GROUP Electrical	MODEL 2015MY Sedona (YP) L, LX & EX Models
	NUMBER PS349	DATE November 2014

SUBJECT: BATTERY REPLACEMENT – FILLER FOAM PAD INSTALLATION

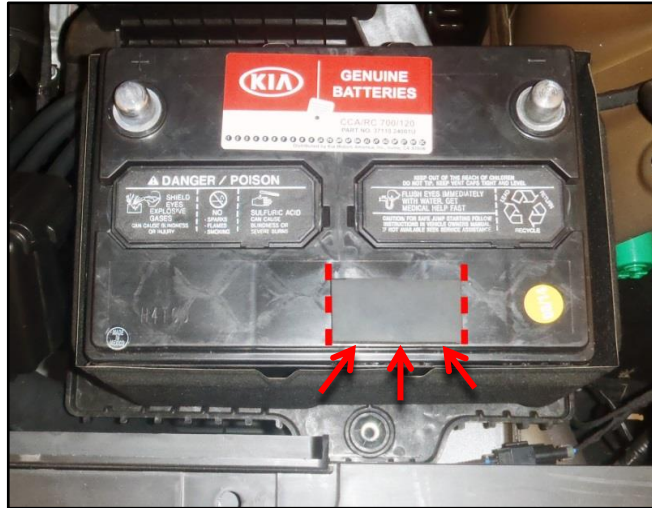
When replacing the OE battery on 2015MY Sedona (YP) (L, LX and EX trim levels ONLY), the replacement battery (P/N 37110 24001U) height is slightly different than the OE battery. A filler foam pad (P/N A9087 ADU00) will be necessary to close the gap between the battery top and upper L bracket of the hold down clamp. Follow the procedure outlined below to install the pad.

1. Remove the OE battery.
2. Install the replacement battery and OE insulation jacket.
3. Temporarily re-install the upper L bracket and use a paint marker to create alignment marks on either side of the bracket, as shown below.

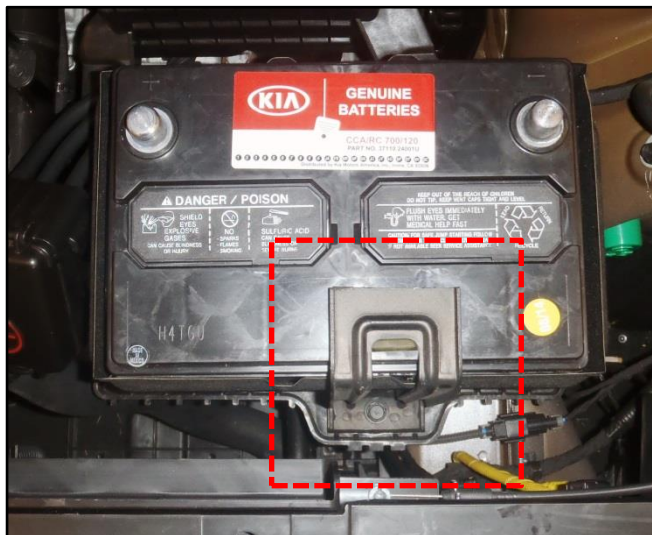
4. Remove the protective film from the bottom of the foam pad.
5. Use the alignment marks created on step 3 to adhere the foam pad to the battery surface, as shown below. **Note: make sure to clean the battery surface prior to installation and align the edge of the foam pad with the edge of the battery.**

6. Install the upper L bracket and torque the bolt to 7.2 ~ 8.7 lb-ft.
